TOWN OF CHAPIN
Planning Commission Regular Meeting Agenda
Council Chambers, Chapin Town Hall
September 9, 2025
4:00 PM

Staff Evaluation of Development Planning Commission

Property Location: 515 Columbia Ave
Tax Map Number: 000700-01-017
Property Zoning District: Corridor Commercial (CC)
Property Overlay District: Corridor
Applicant: Brittany Youngblood – Express Oil (EO)

RE: Trip Generation Assessment for Express Oil Change & Tire Engineers – Trip Generation Assessment

SITE PLAN

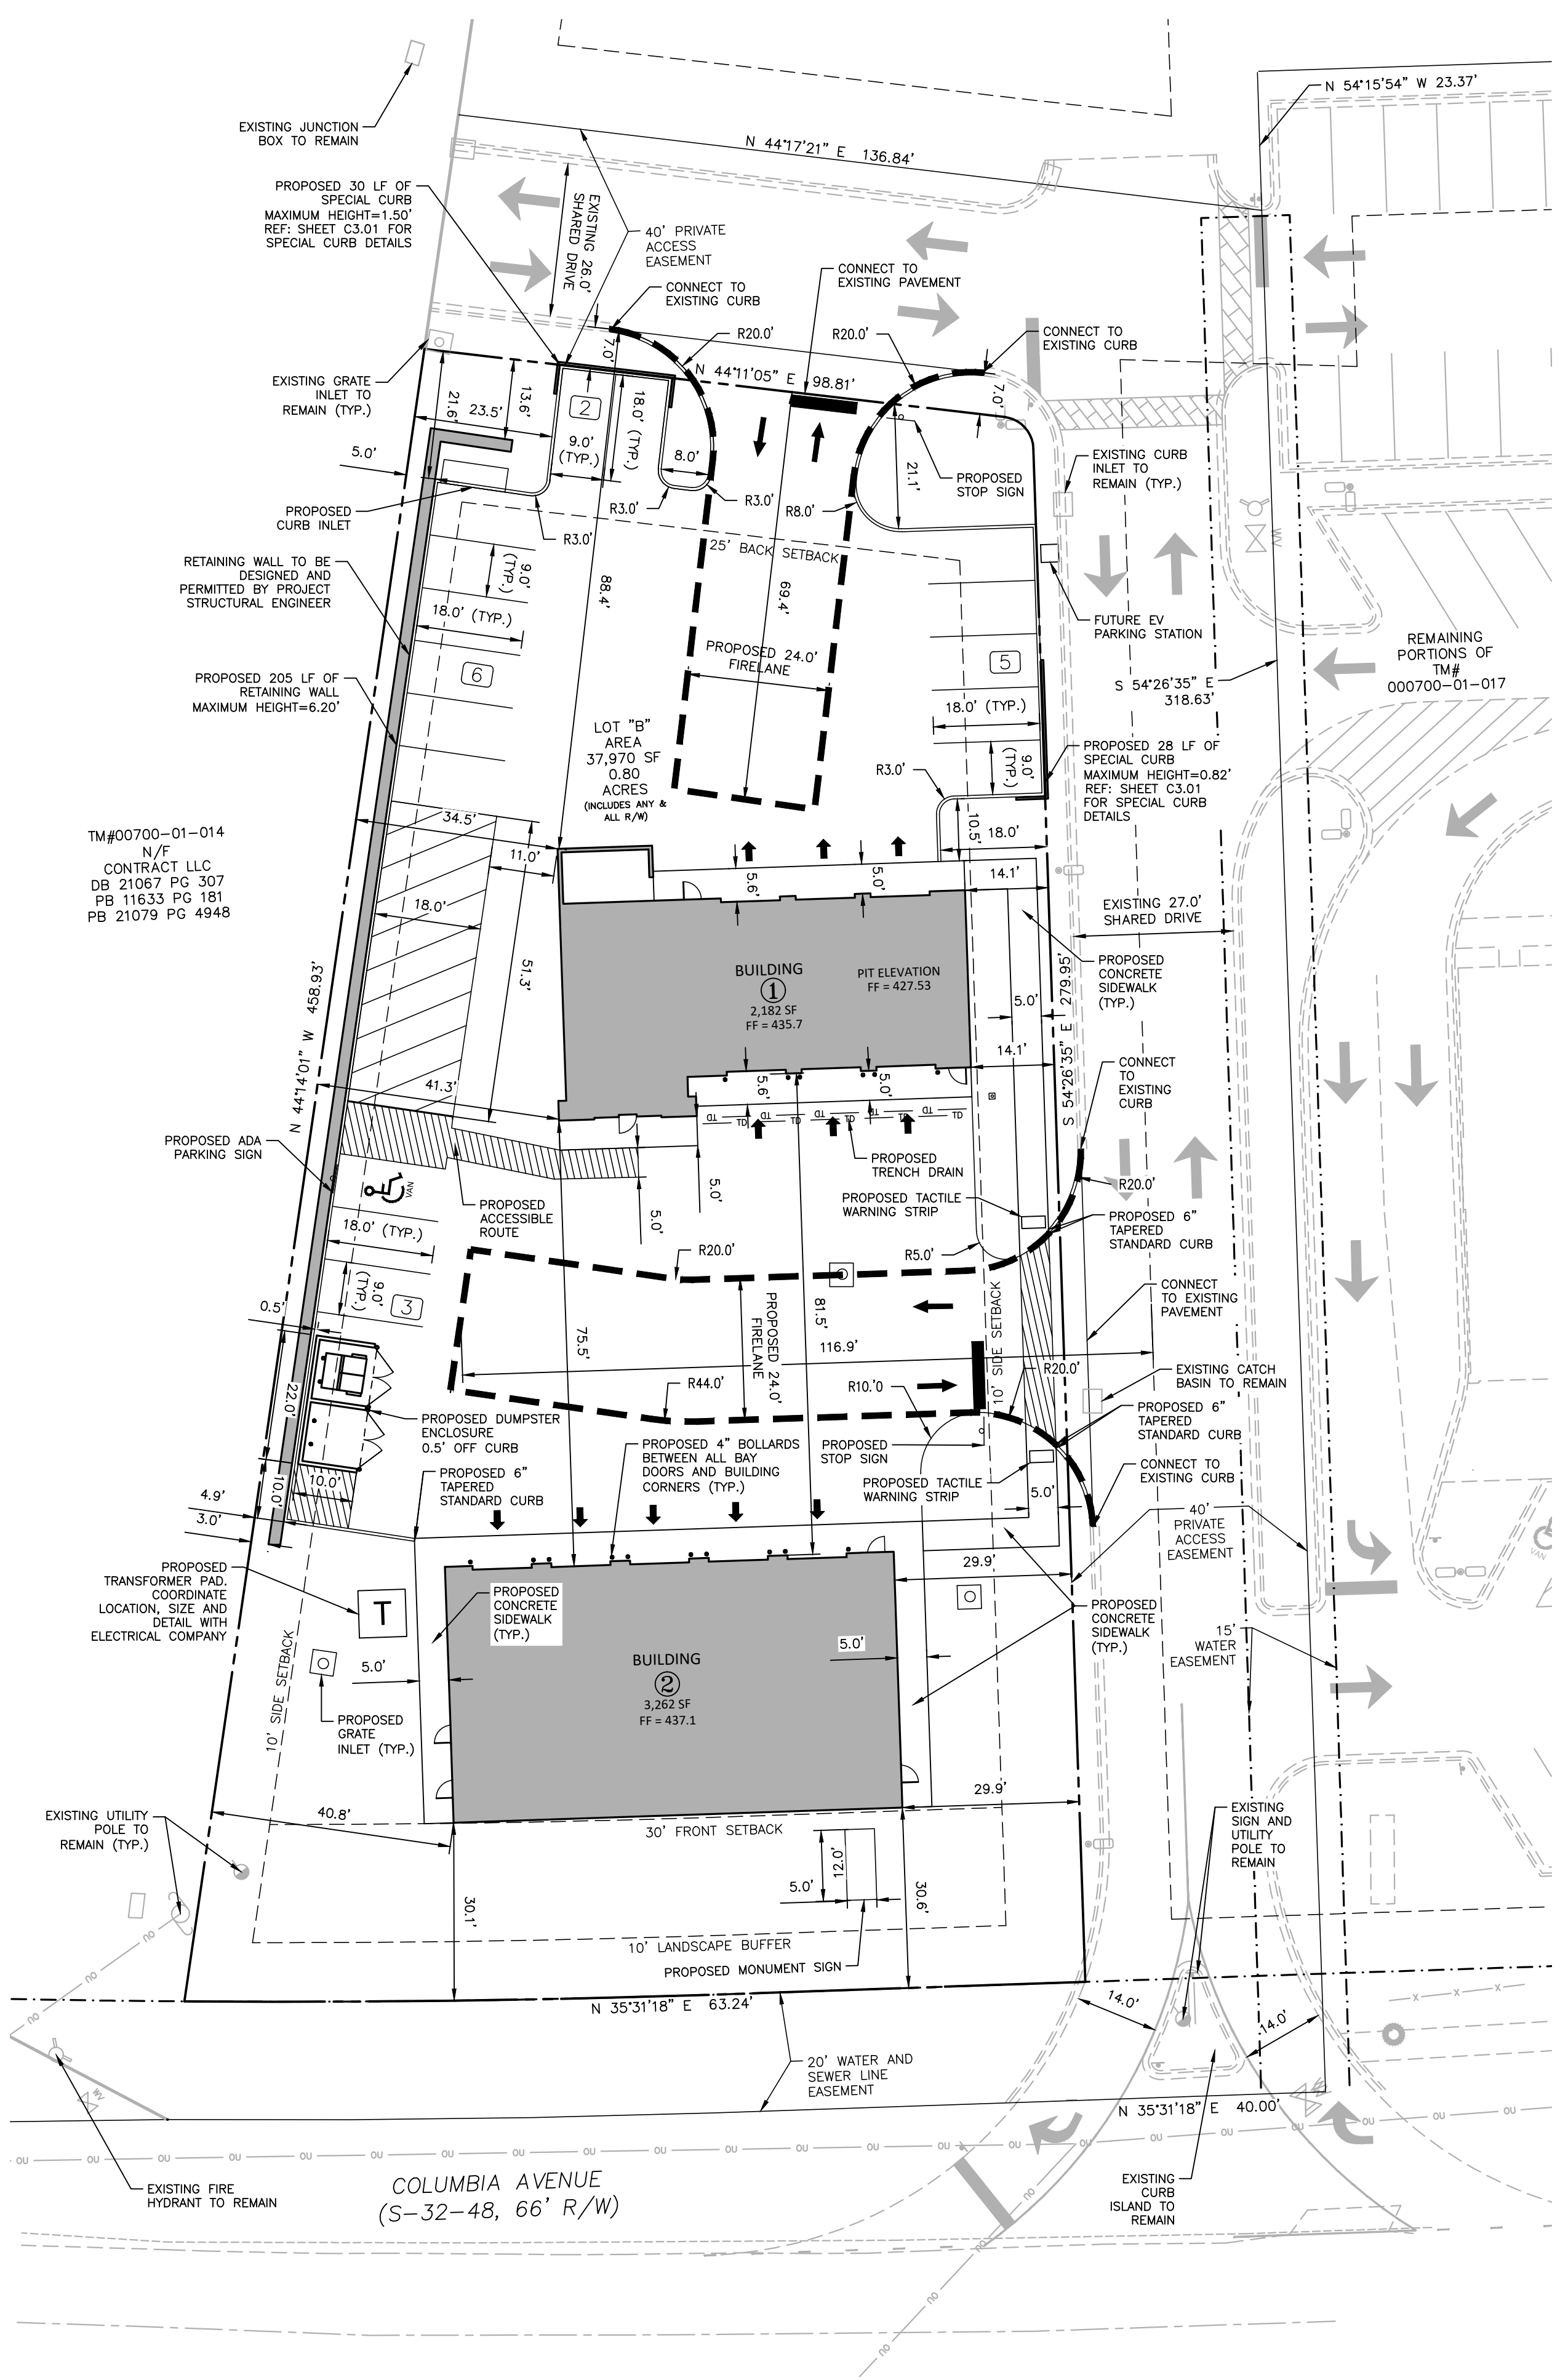
Total size of the building is 2957 Sq. Ft. / 1 space per 150 Sf = 25 Spaces. Applicant has planned for 13 spaces. Appears to be short of minimum required.

- Requested further documentation to ensure landscape and tree mitigation details. Peach (McAlister's) responsible for clearing and replacement landscaping of sub-division. **Need full site plan. Code 7.6.6**

- In accordance with Code – required tree mitigation would be 11 trees added to CW for replacement. **(1 canopy tree per 6000sq ft) 6 trees planned for EO – Side note** McAllister's responsible for entire tree mitigation project.**

- Parking appears to be short of the minimum required. 25 (Table 8.4.1) **Request written agreement for overflow spaces with others.**
- Lighting plan coordination with others in sub-division.

- Request more information with traffic study to overall site and determine CW entrance and proposed Express Oil entrance / exit on interconnected roadway is clear of any congestion problems. **Kimley >>Horn is working on an update study for entire project layout.**

- Recommend 3rd party review of TIS for mitigation with traffic and all access points to eliminate congestion.
